**SUBJECT:** Calvert Cliffs Nuclear Power Plant  
Unit Nos. 1 & 2; Docket Nos. 50-317 & 50-318  
Core Operating Limits Reports for Unit 1, Cycle 15, Revision 5 and Unit 2,  
Cycle 14, Revision 2

**UNIT 1, CYCLE 15, REVISION 5**

**UNIT 2, CYCLE 14, REVISION 2**

**Figure 3.2.1-1**

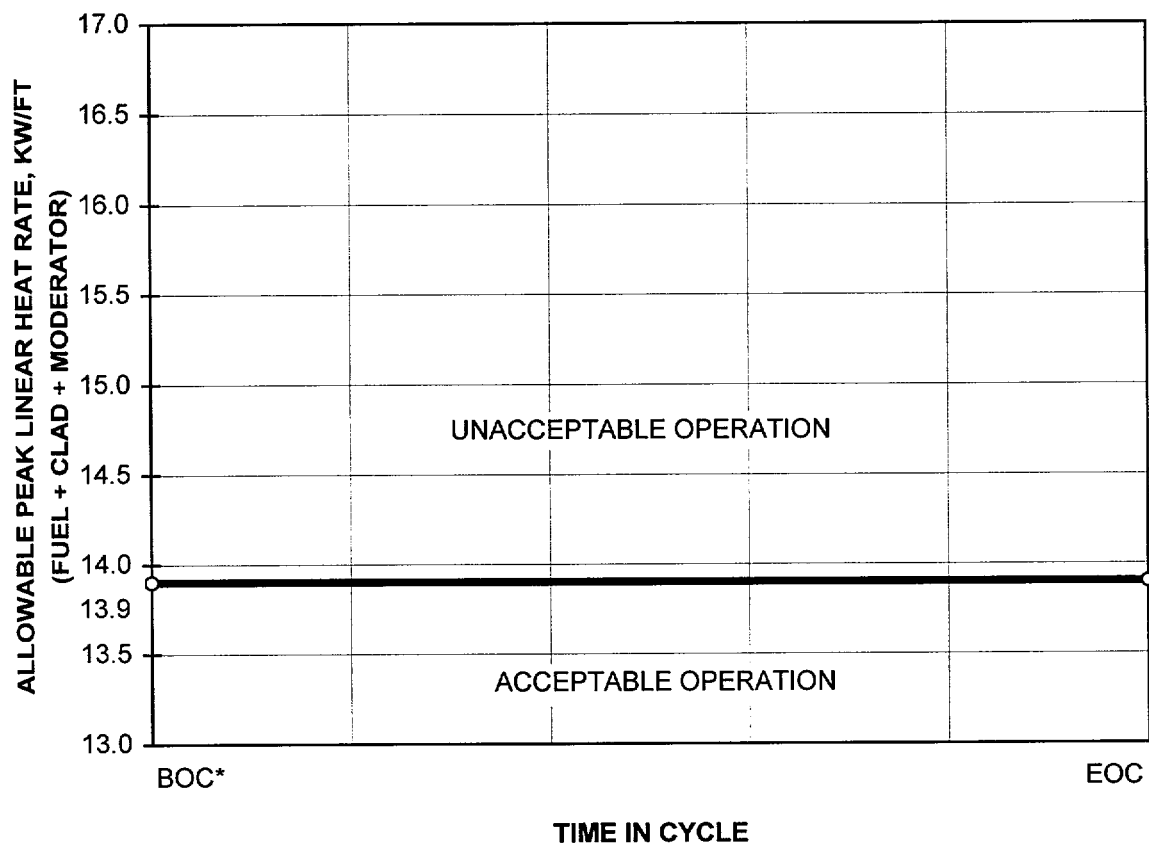
Figures 3.2.1-1 and 3.2.1-3 are revised to lower the allowable PLHR from 14.3 kw/ft to 13.9 kw/ft. Figures 3.2.1-3, 3.2.2, & 3.2.3 are revised to expand the tradeoff curves below 80% power. Finally, Figure 3.2.5 and the list of references are revised to implement the ABB-NV setpoints. (SE00451, Rev. 0000).

**\*Allowable PLHR was changed from 14.3 kw/ft to 13.9 kw/ft mid-cycle**

**Figure 3.2.3**

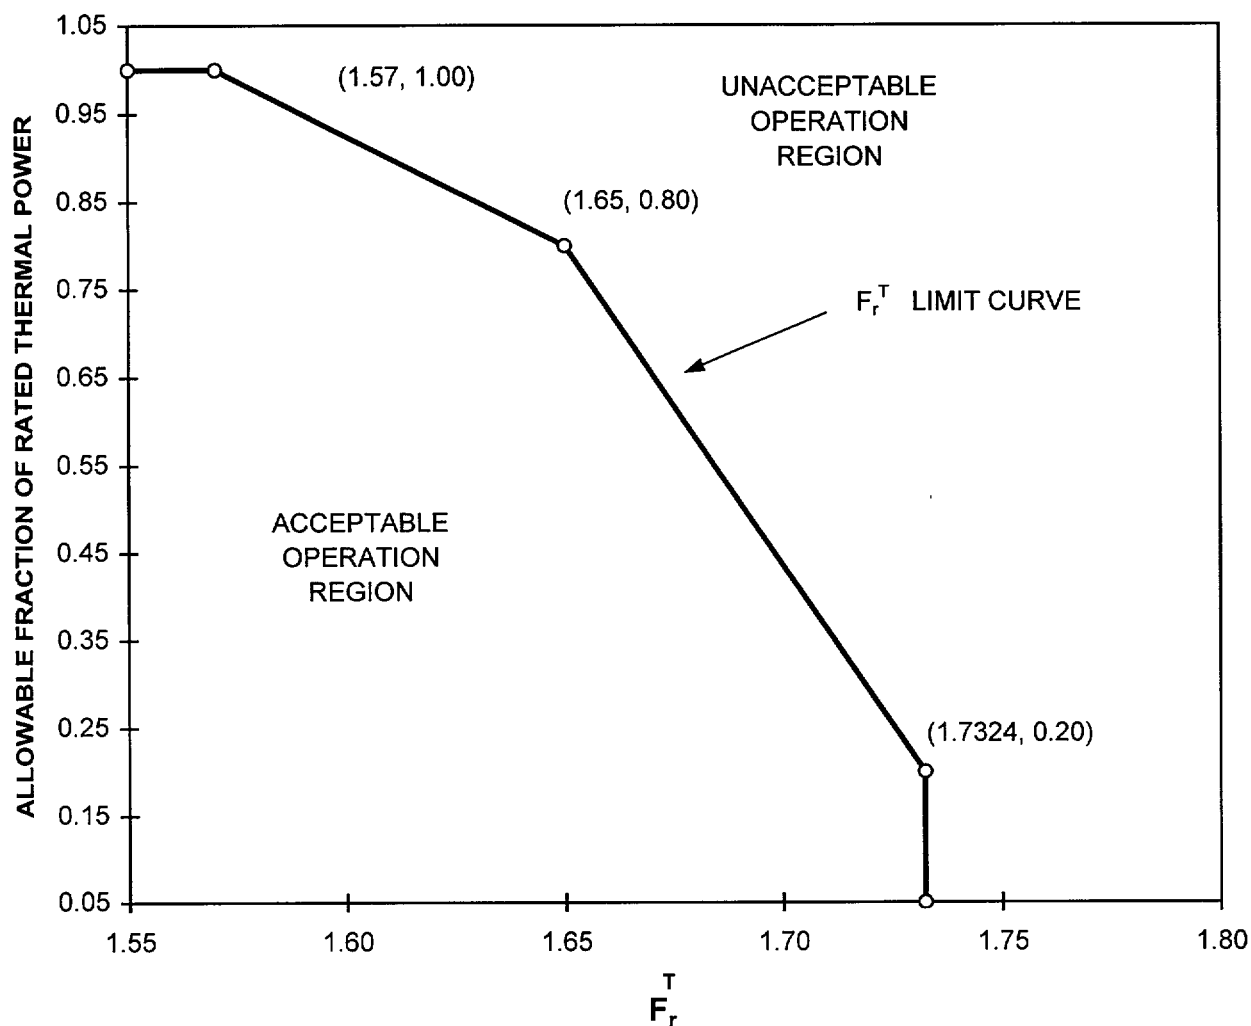
Figure 3.2.3 is revised to implement a more restrictive  $F_r^T$  due to ROPM issues discovered mid-cycle (SE00472, Rev. 0).

**While operating with  $F_r^T$  greater than 1.57, withdraw CEAs to or above the Long Term Steady State Insertion Limits (Figure 3.1.6)**

**Figure 3.2.3**

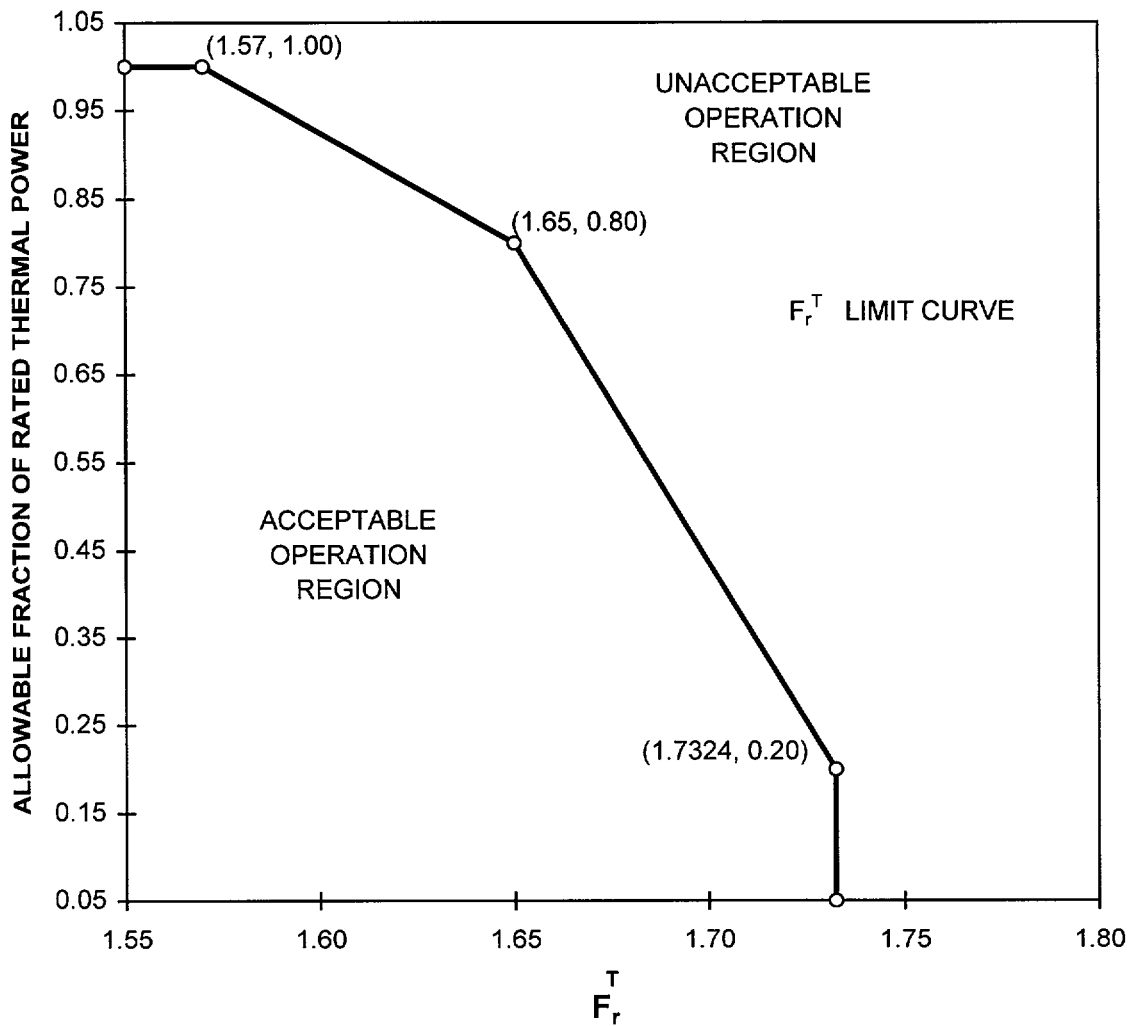
Figure 3.2.3 is revised to implement a more restrictive  $F_r^T$  due to ROPM issues discovered mid-cycle (SE00472, Rev. 0).

**While operating with  $F_r^T$  greater than 1.57, withdraw CEAs to or above the Long Term Steady State Insertion Limits (Figure 3.1.6)**
